June 22, 1979

Dockets Nos.: 50-269
50-270
and 50-287✓

The Commission has issued the enclosed Amendments Nos. 73, 73 and 70 for Licenses Nos. DPR-38, DPR-47 and DPR-55 for the Oconee Nuclear Station, Units Nos. 1, 2 and 3. These amendments consist of changes to the Station's common Technical Specifications and are in response to your request dated March 30, 1979, as supplemented May 17, 1979.

These amendments revise the Technical Specifications to support the operation of Oconee Unit No. 3 at full rated power during Cycle 5. The amendments also revise the Technical Specifications for Units Nos. 1, 2 and 3 in regard to power level cut-off.

OCONEE NUCLEAR STATION
Figure 2.1-2C

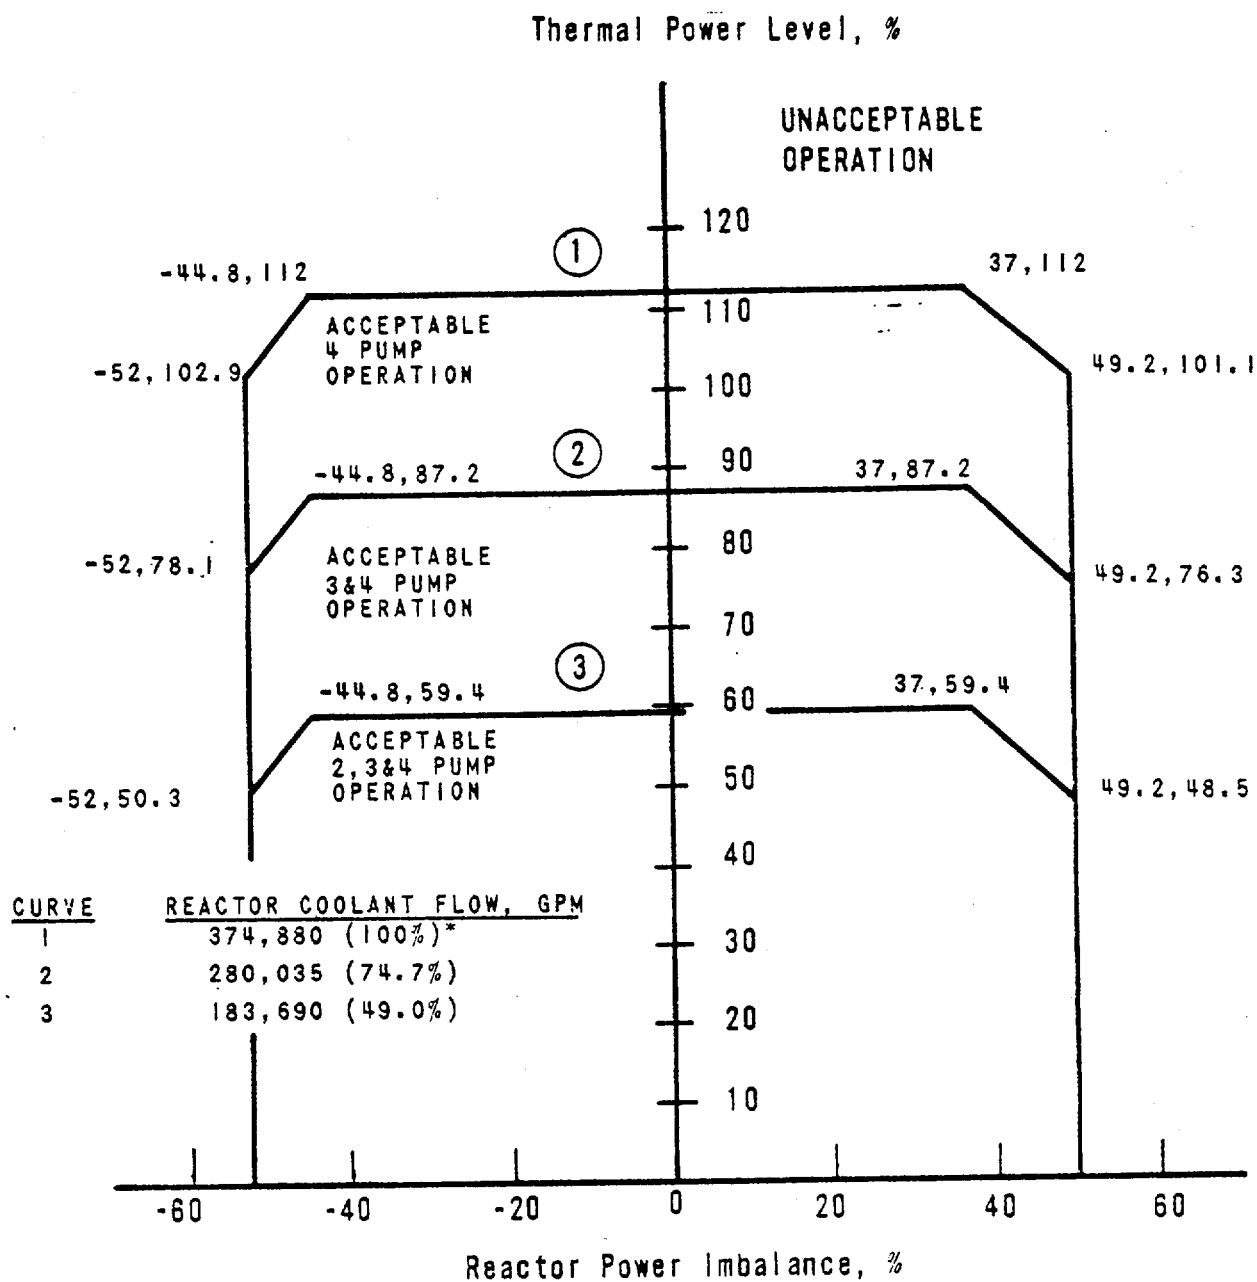
The specified flow rates for Curves 1, 2 and 3 of Figure 2.1-2C correspond to the expected minimum flow rates with four pumps, three pumps and one pump in each loop, respectively.

The maximum thermal power for three-pump operation is 87.2 percent due to a power level trip produced by the flux-flow ratio $74.7 \text{ percent flow} \times 1.08 = 80.7 \text{ percent power}$ plus the maximum calibration and instrument error (Reference 4). The maximum thermal power for other coolant pump conditions are produced in a similar manner.

Figure 2.3-2C

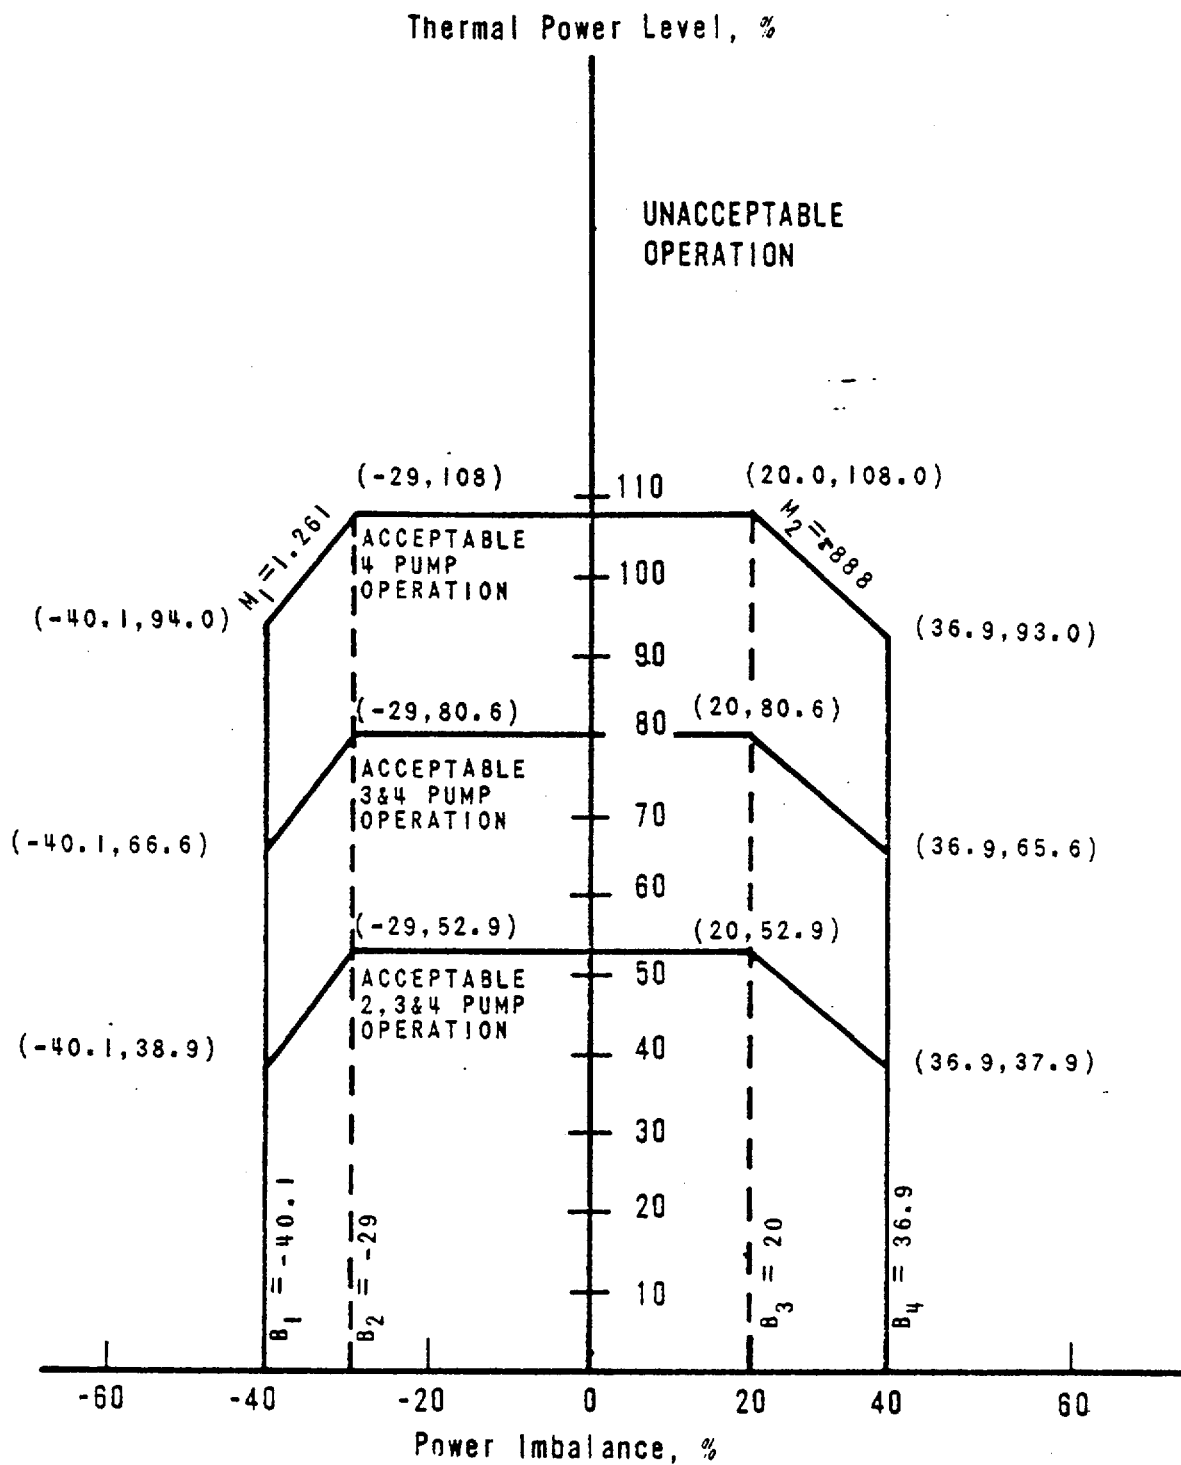
The high reactor coolant outlet temperature trip setting limit (619°F) shown in Figure 2.3-1A has been established to prevent excessive core coolant

temperatures in the operating range. Due to calibration and instrumentation errors, the safety analysis used a trip setpoint of 620°F.
